To **GRE-72-07**
Comments to GTB draft proposal

Tomasz Targosinski Ph. D. Eng

72 GRE 20-22 October 2014

TRANSLATION OF **SCREEN PHOTOMETRY** TO ROAD $H=0.75m$, $I=1\%D$

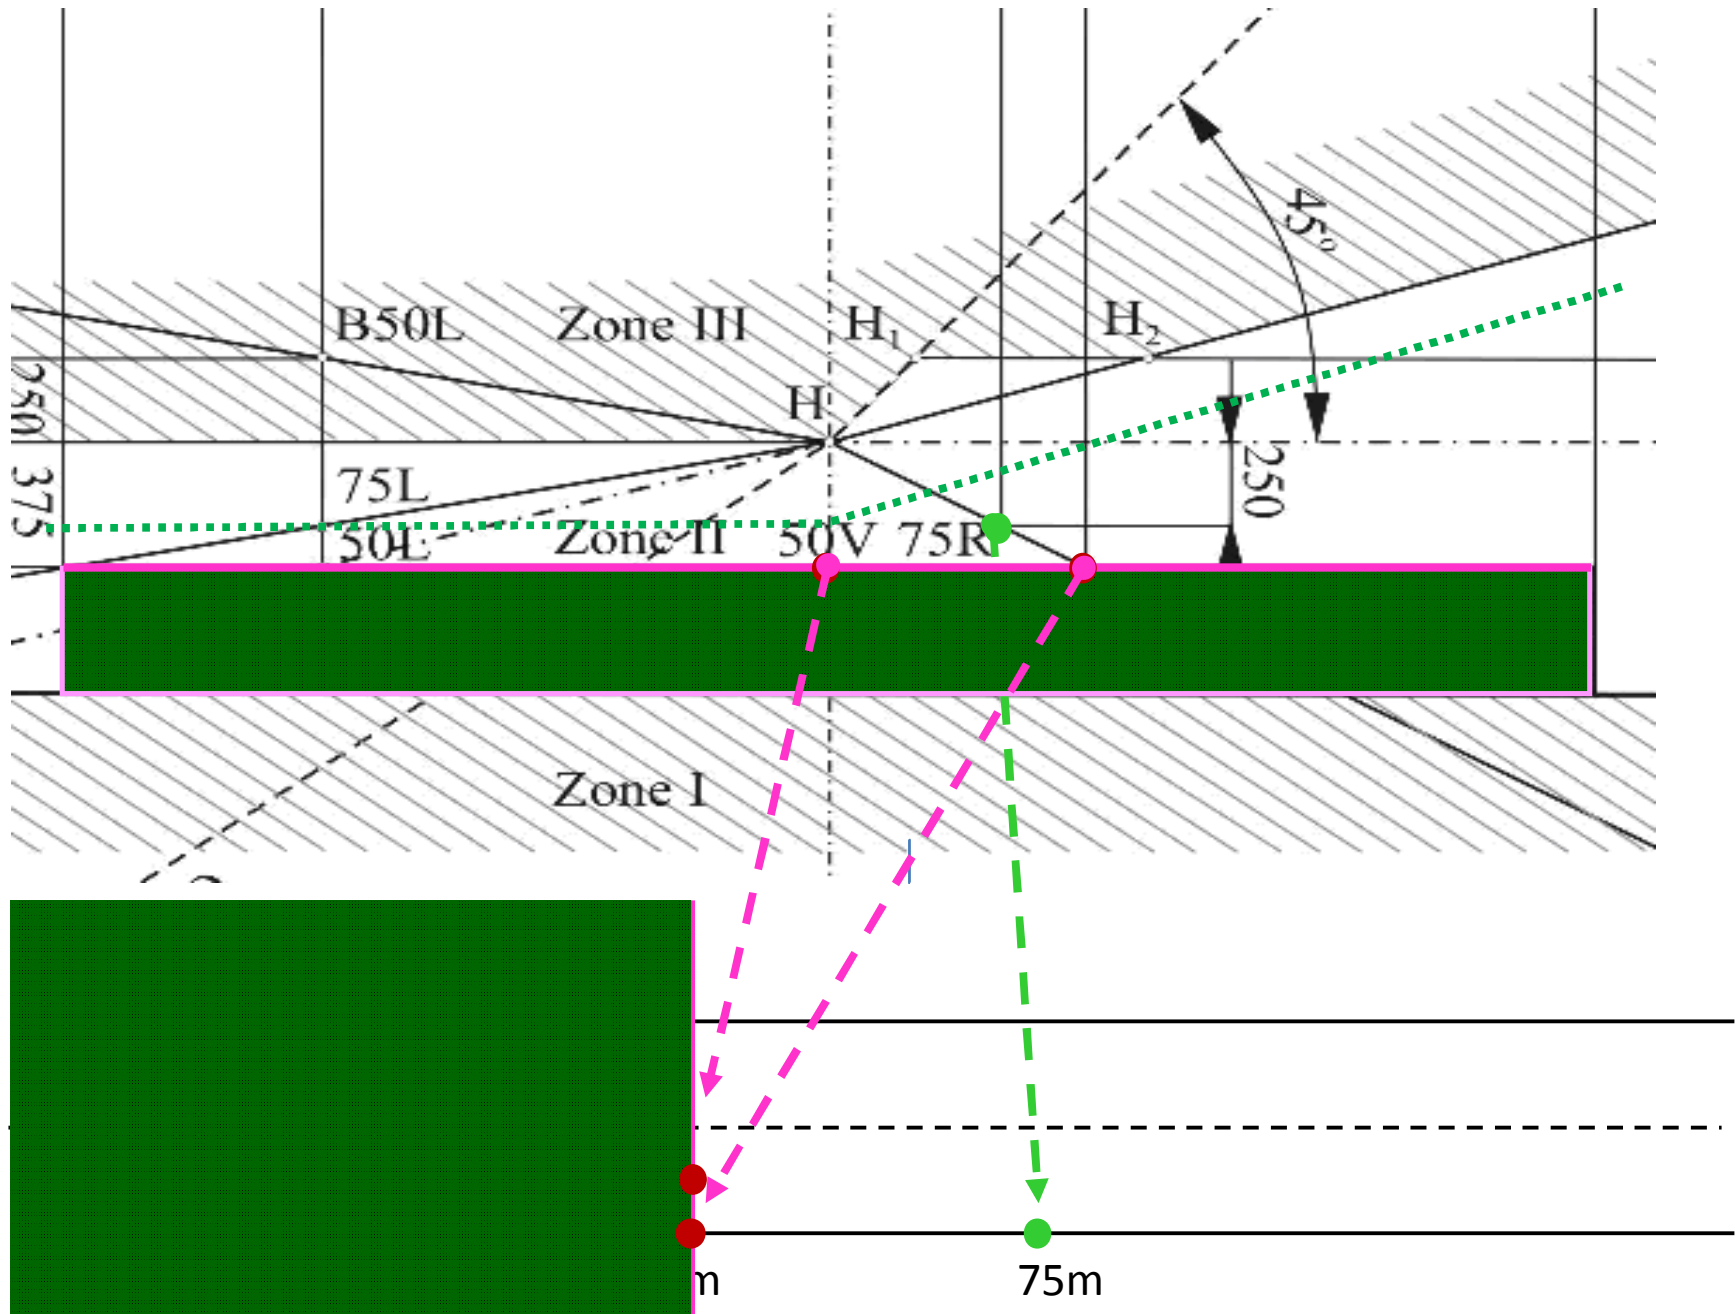
Illuminances from 25 m screen translated to the road by headlamp mounting height (h) of 75 cm

For 75R the minimum value is 16.8 lux @25m

Illuminance at 75 m = $16.8 / (75/25)^2 = \mathbf{1.87 \text{ Lux}}$ at the road surface.

TRANSLATION OF SCREEN PHOTOMETRY TO ROAD H=0.75m, l=1%D

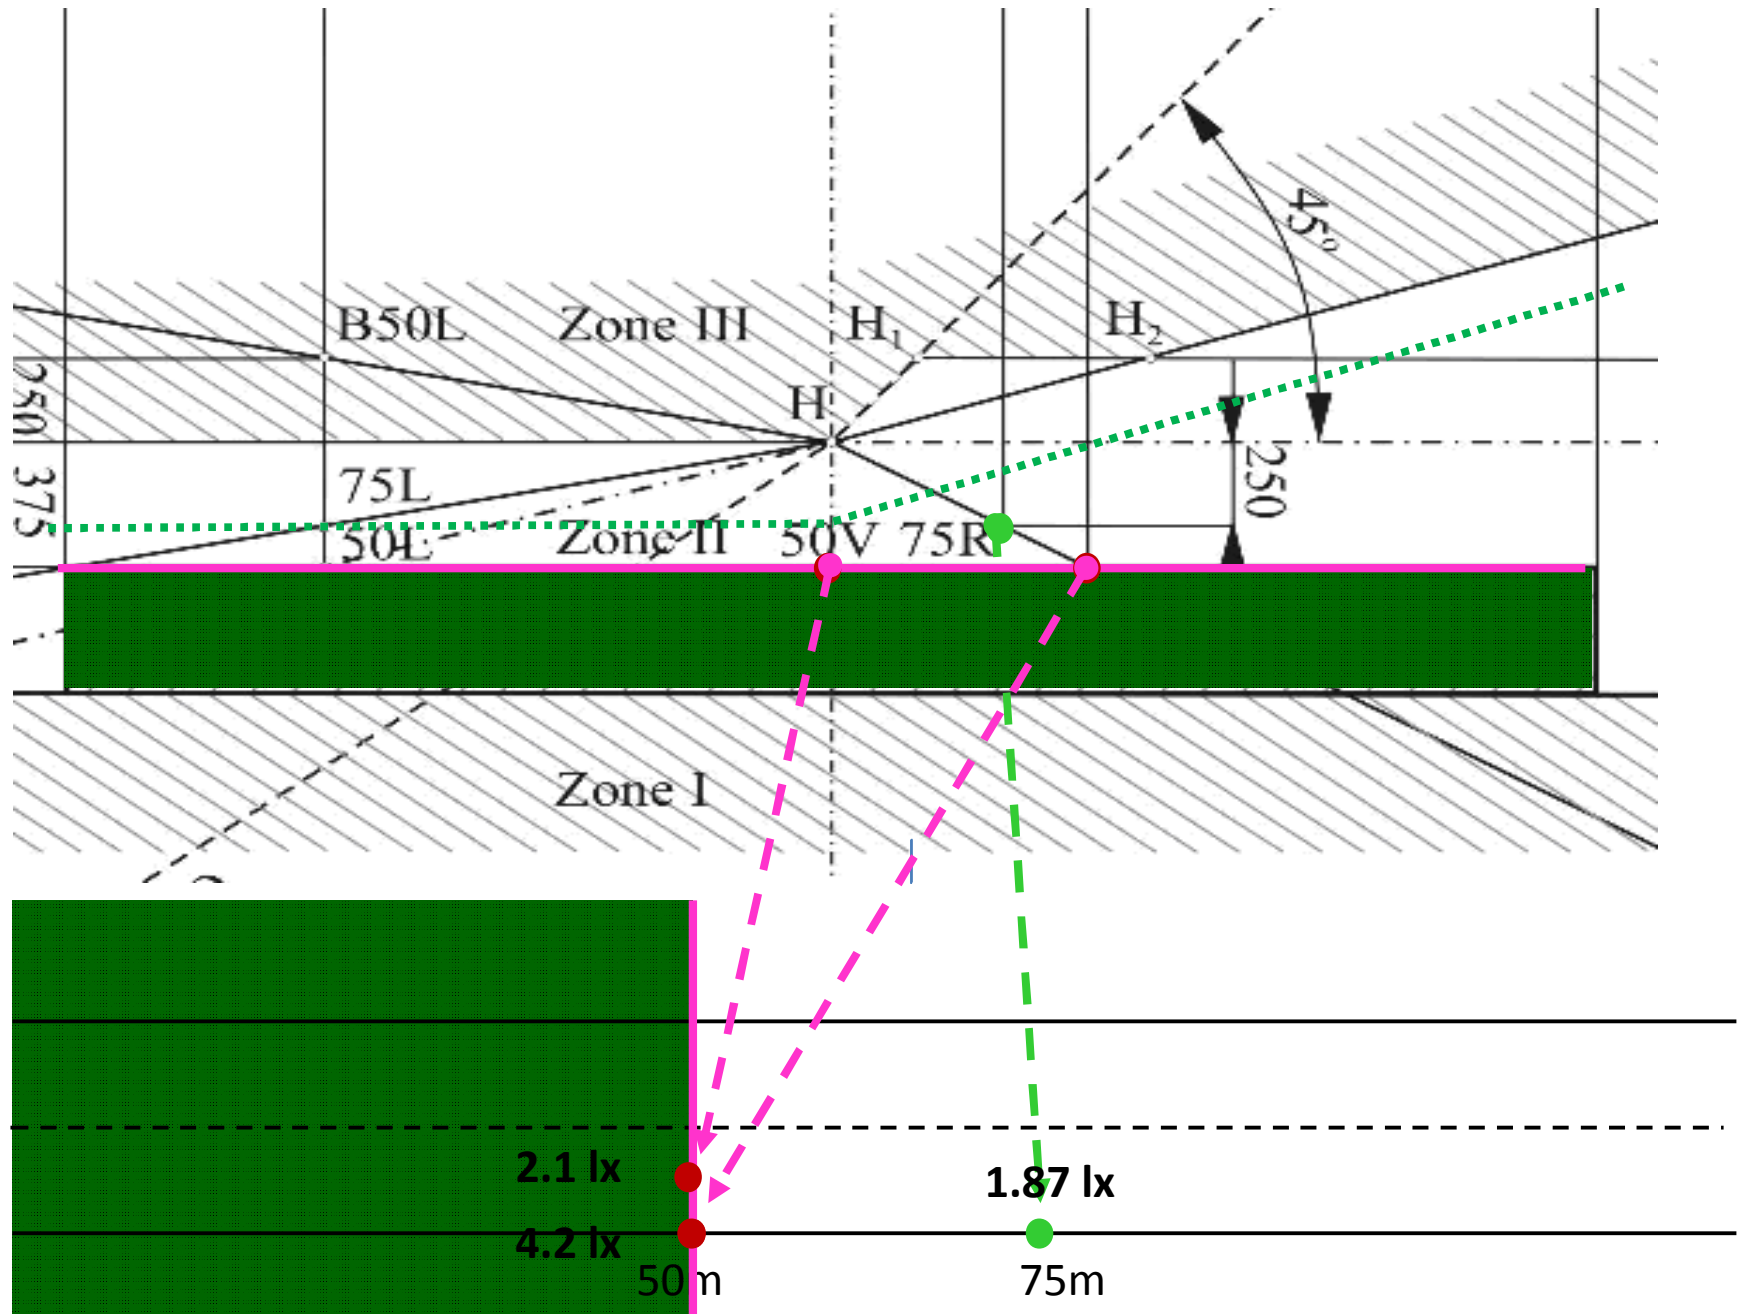
For 50R the minimum value is 16.8 lux @25m

Illuminance at 50m = $16.8 / (50/25)^2 = \mathbf{4.2 \text{ Lux}}$ at the road surface.

For 50V the minimum value is 8.4 lux @25m

Illuminance at 50m = $8.4 / (50/25)^2 = \mathbf{2.1 \text{ Lux}}$ at the road surface.

Poland proposed road illumination connected extended levelling tolerances

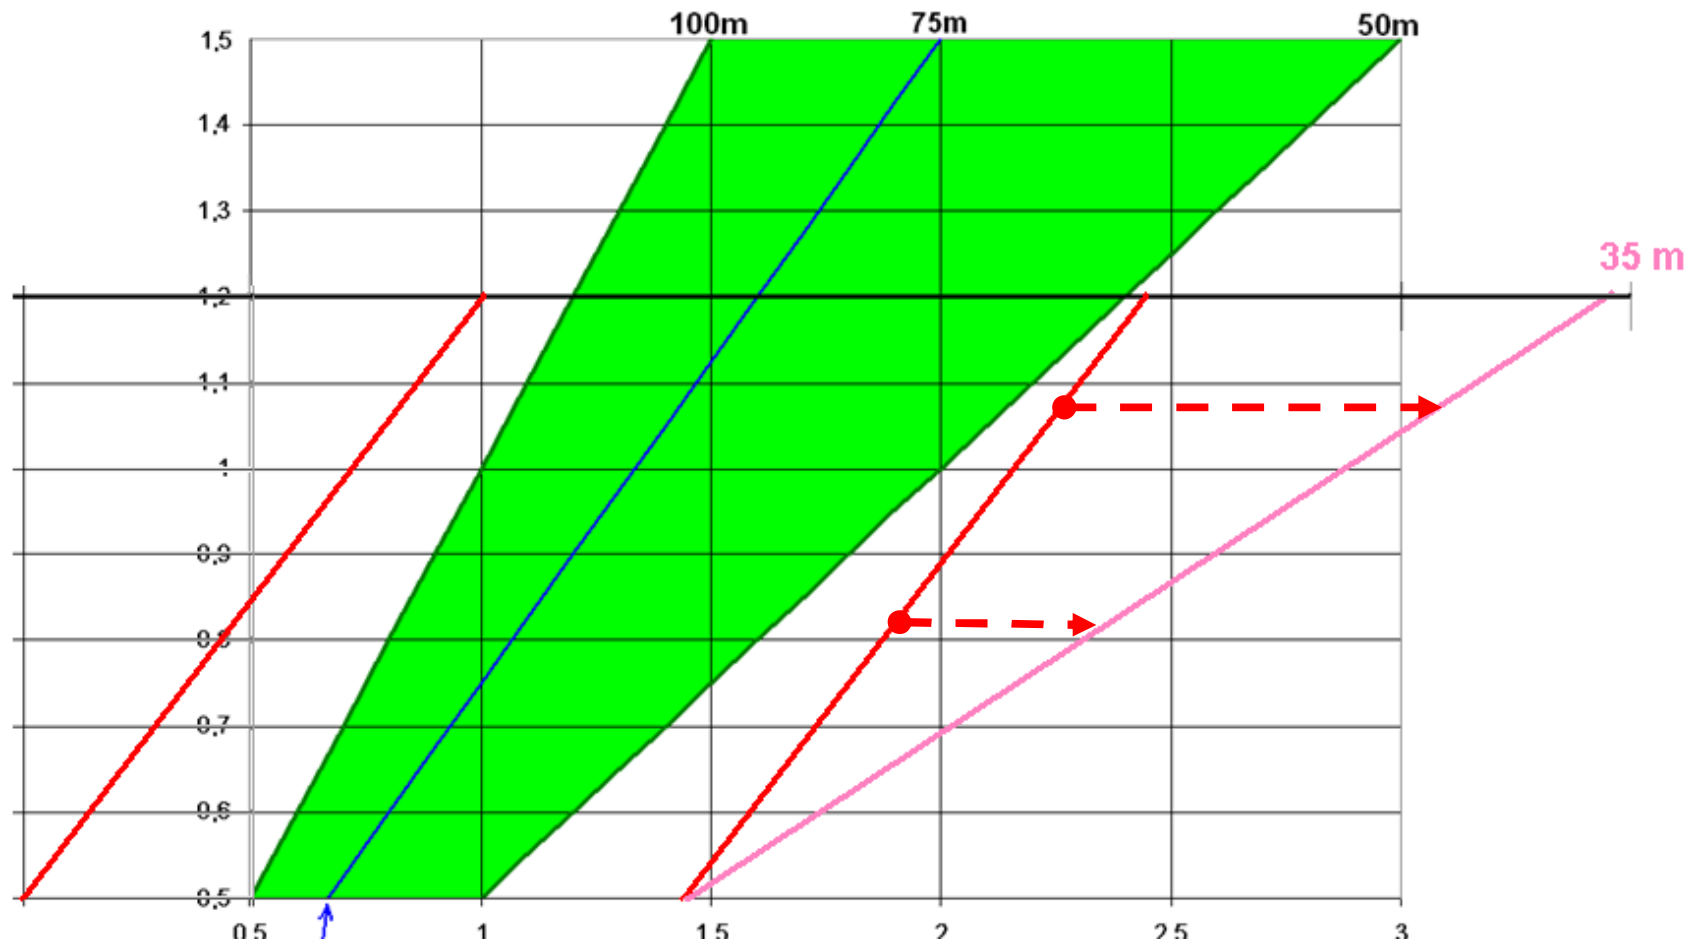
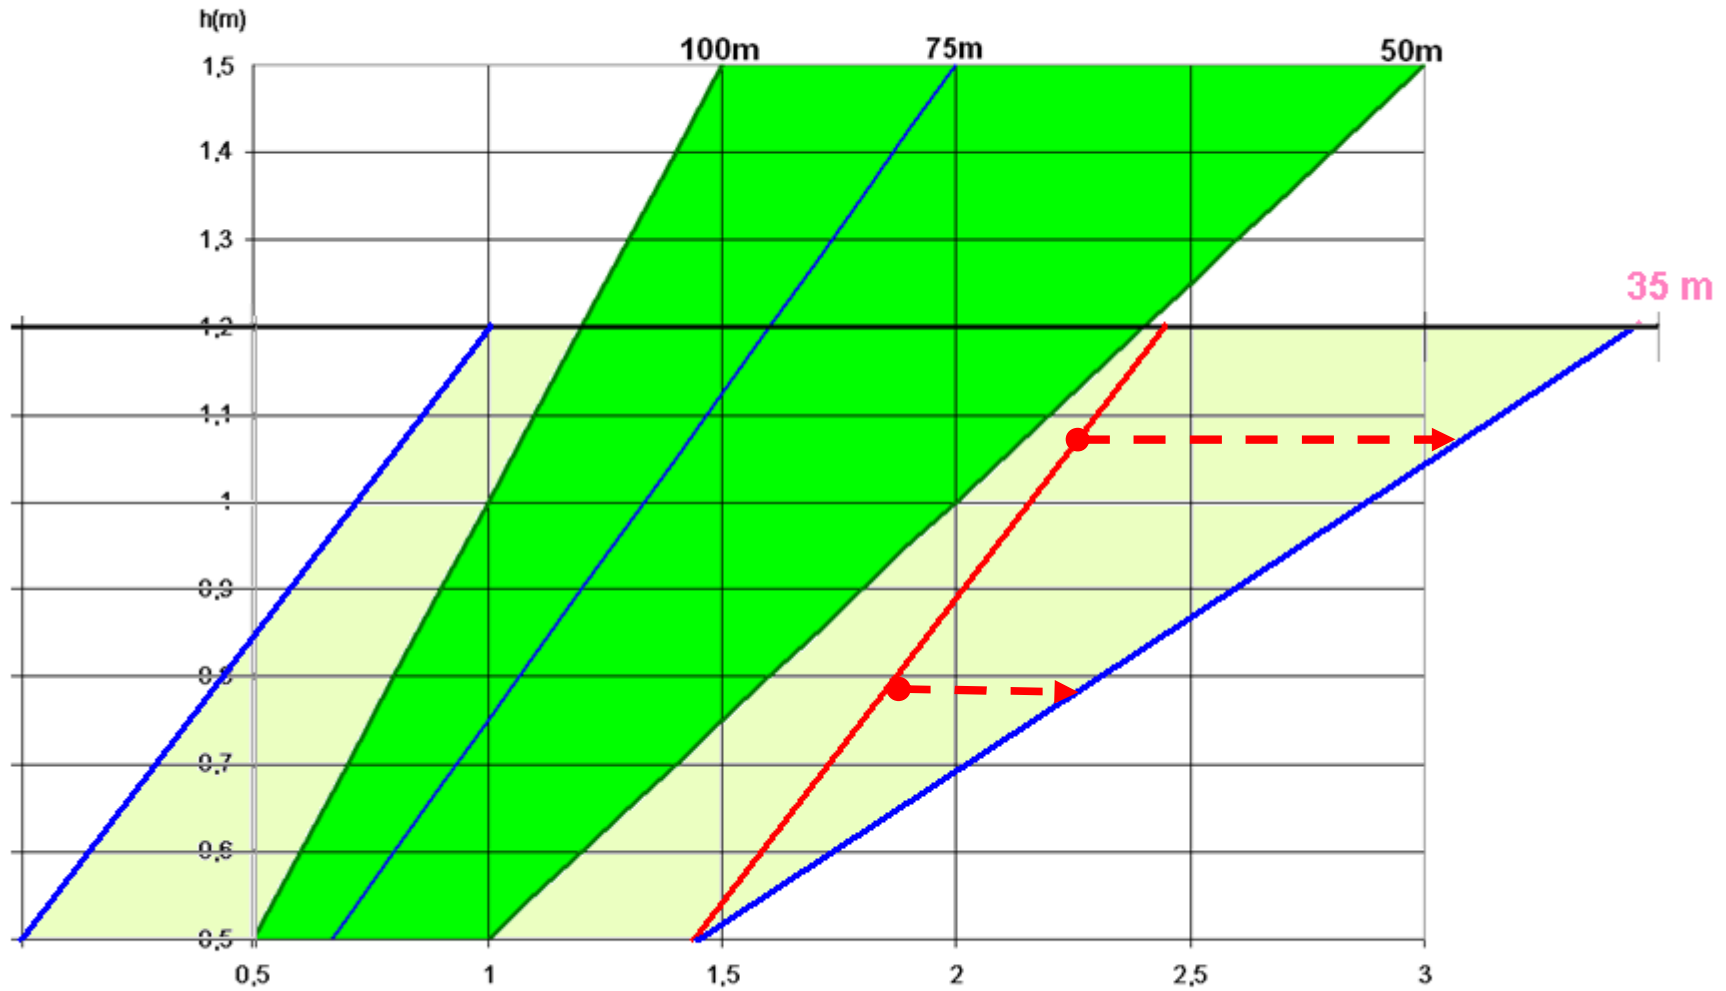
Poland proposed road illumination connected extended levelling tollerances

REAL VEHICLE PITCH CHANGE WITH LOADING

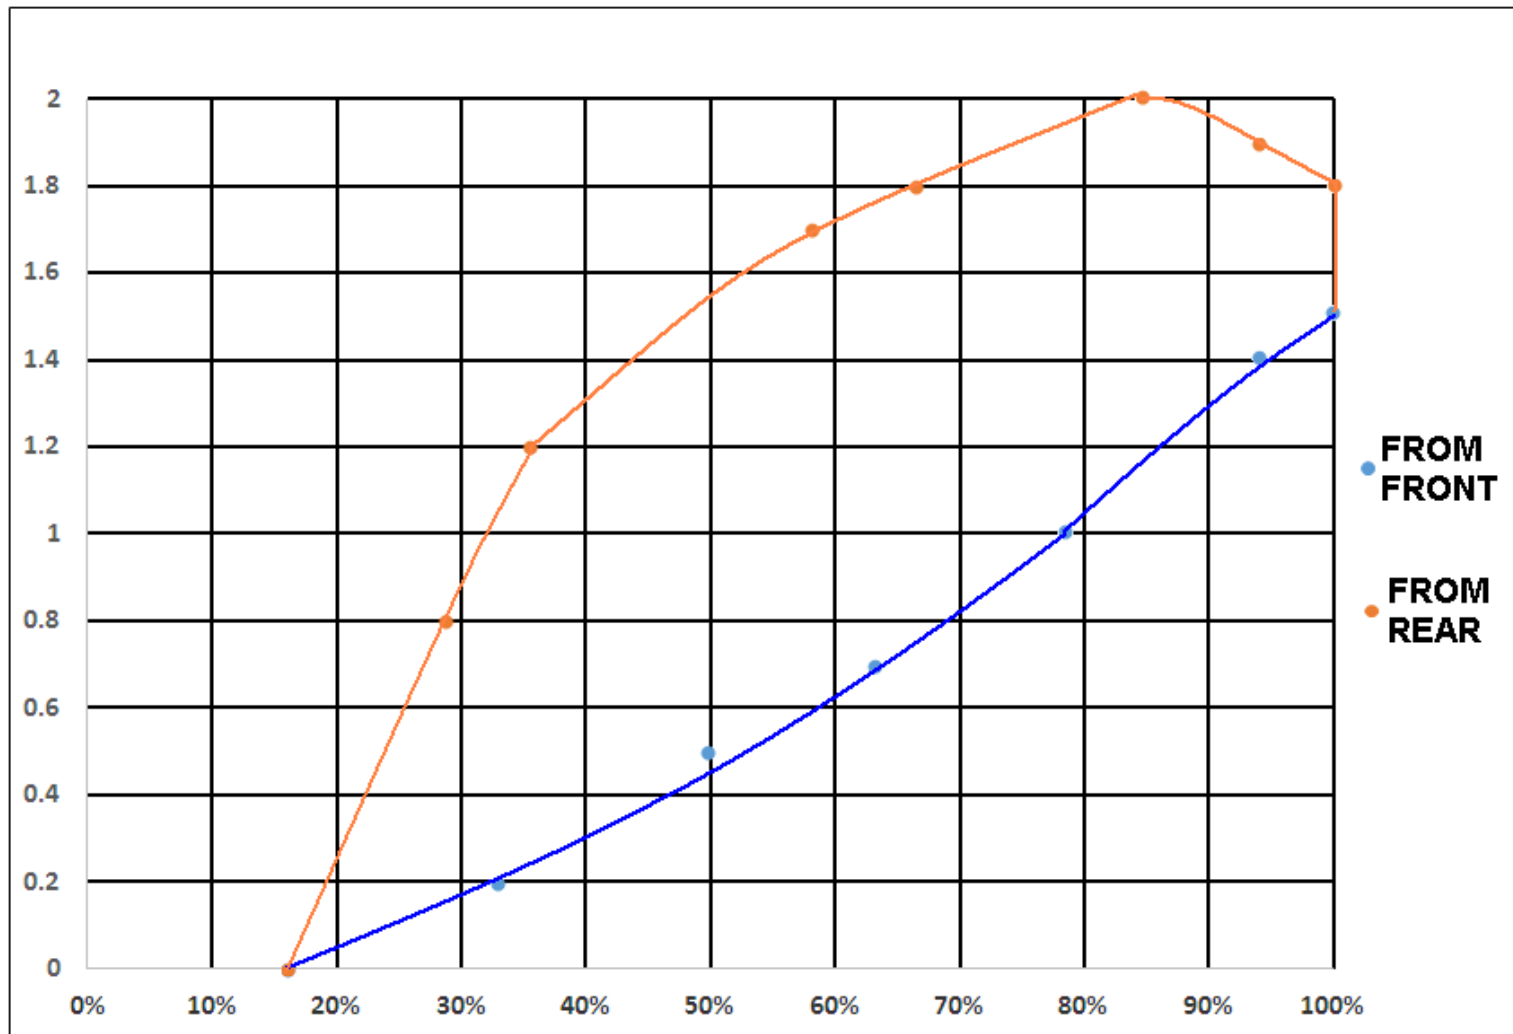
Proposal instead 50% - requirements

Manufacturer should submit characteristics of pitch change with load for two extreme manners of load distribution:

- The first one causing the highest cut-off inclination.*
- The second one causing the lowest cut-off inclination.*

It should be expressed all distinguished situation of load in the way possible to verify as number of passenger at given seats, load quantity and distribution etc. It should be done with resolution not less than 5% of full load and expressed in % and kilograms.

Fuel quantity in tank should be treated as a load factor in two stage: full and reserve.

Manufacturer should declare the value of cut-off inclination change when switch from "UP" to "DOWN" position.
